**A RESOLUTION OF THE TOWNSHIP OF NORTH BRUNSWICK
AUTHORIZING CHANGE ORDERS 19, 20, 21, 22 AND 23 WITH
BROCKWELL AND CARRINGTON CONTRACTORS, INC.
FOR SUPPLEMENTAL WORK AS PART OF THE
RESTORATION PHASE OF THE MUNICIPAL COMPLEX**

Brockwell and Carrington
Municipal Complex Façade Project

PROJECT: NBER – North Brunswick Envelope Restoration

BUILDING ENVELOPE RESTORATION
 AT THE
MUNICIPAL BUILDING
 FOR THE
TOWNSHIP OF NORTH BRUNSWICK
 710 HERMANN ROAD, NORTH BRUNSWICK, MIDDLESEX COUNTY, NJ 08902
 BLOCK 213, LOT 7

Drawing Title: DETAILS	
Drawing No.: RFI#22-SK01	
Reference RFI: RFI#22	Reference Drawing: A-440
USA Project No.: 2023-042	
Drawn By: KMB	Checked By: MJB
Date: 01/13/25	Page: 1 of 2

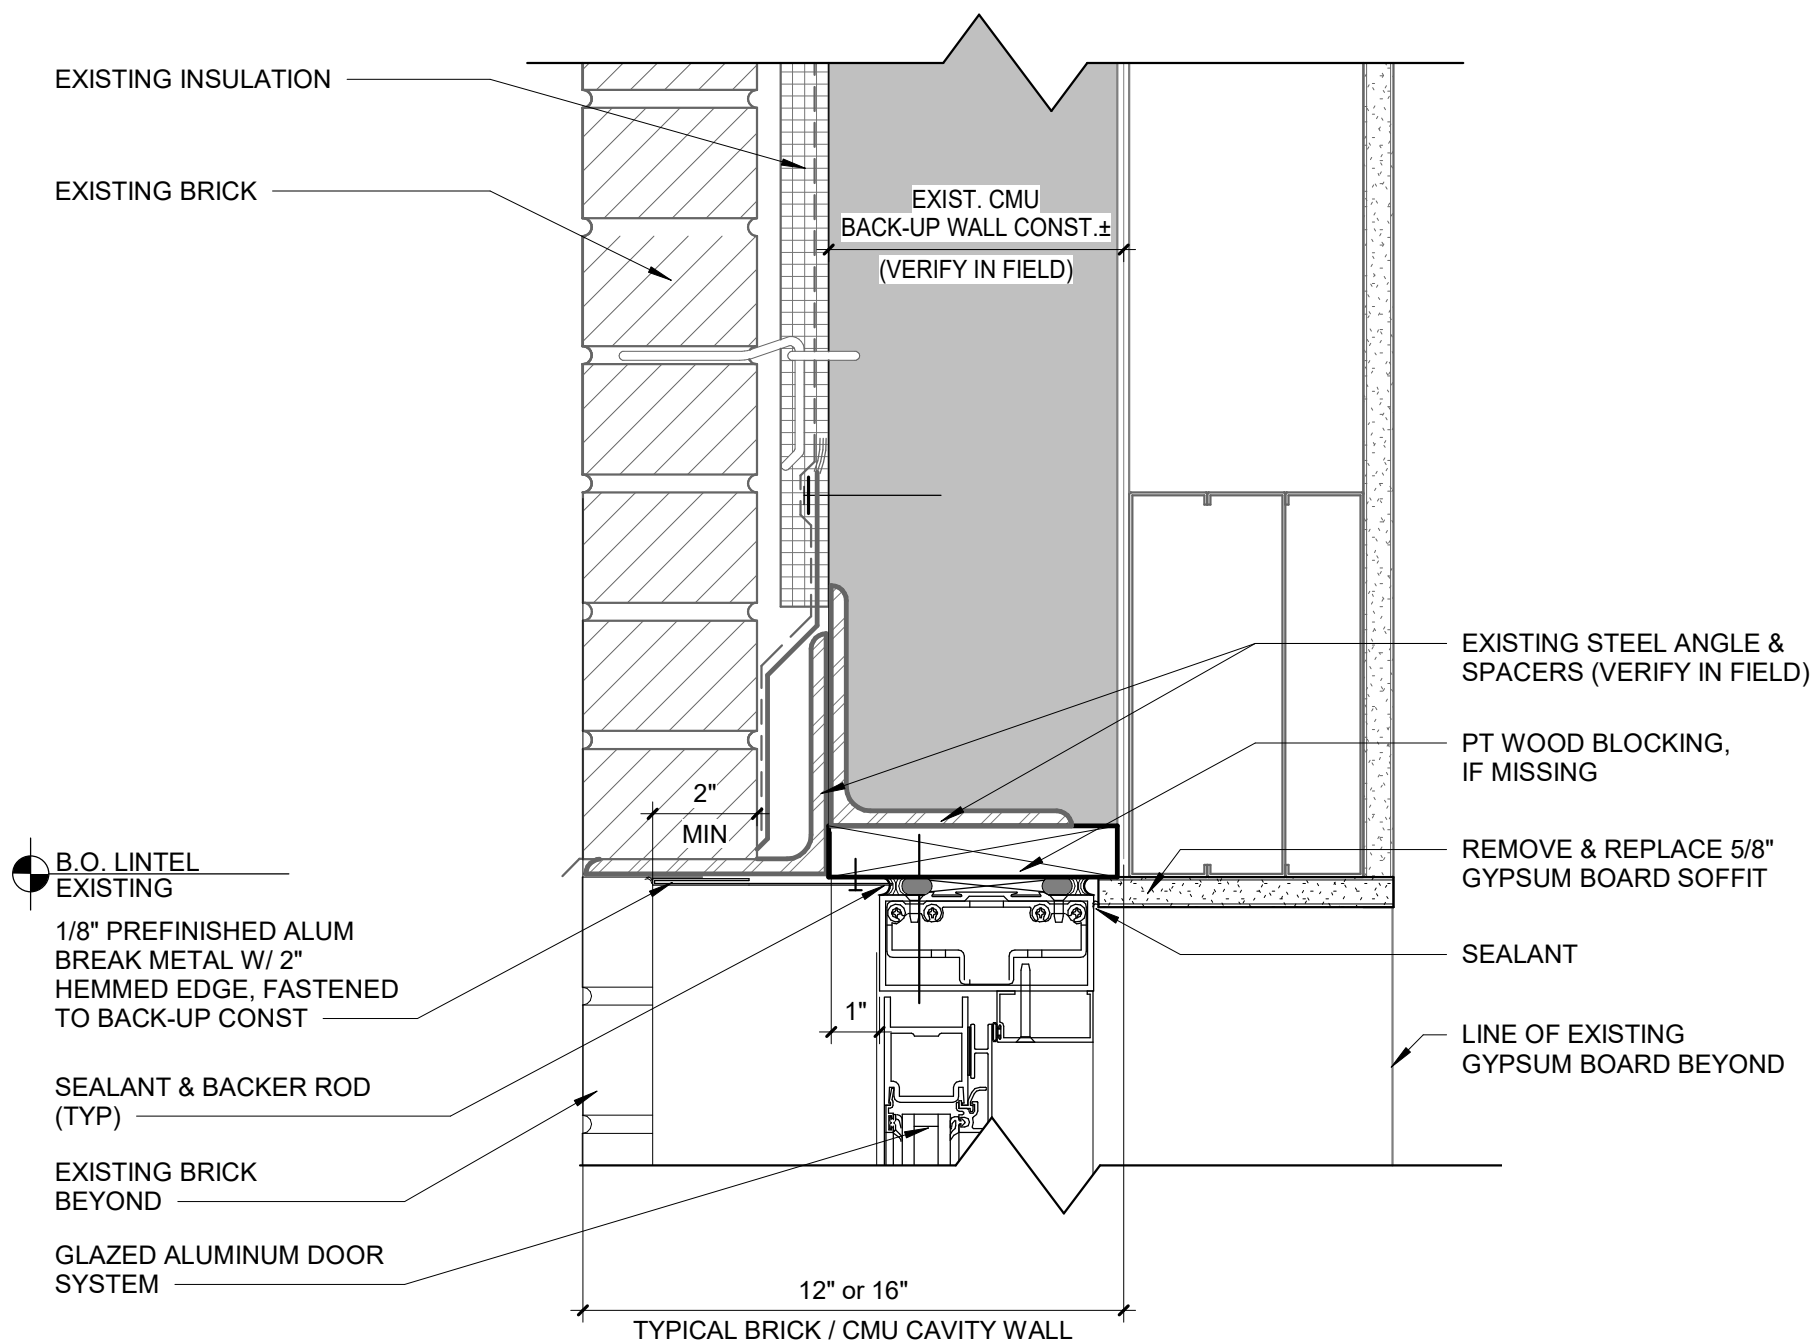
SUBJECT: NBER- Missing Blocking Remediation Revision

Scope: Per the attached sketches, additional cost required to address the condition as referenced in RFI #22.

- Fabricate and install (106 LF) of 8” X 1/16” X 7’/6” legs and 3’/4” , 5’/0” & 7’/6” head pieces. For (5) door openings. (Note: Aluminum to be made by folding 1/16” aluminum plate creating 1/8” at the outside 2” hemmed edge. Install aluminum plates over double sided Butyl tape, silicone, stainless steel anchors shielded into brick including mineral wool insulation at voids, backer rod at frame and silicone sealant as required.
- Furnish and install (5) 12” wide PEMKO 2550A aluminum thresholds set in bed of sealant with recommended shields and anchor.
- Install required wood blocking/backing and repair drywall returns, beads and tape/finish as required.
- Patch and paint drywall with owner supplied attic stock paint and vinyl wall base.

Note: Closure plates to be clear anodized and shop painted with DTM color matched paint Slate Gray UC130121.
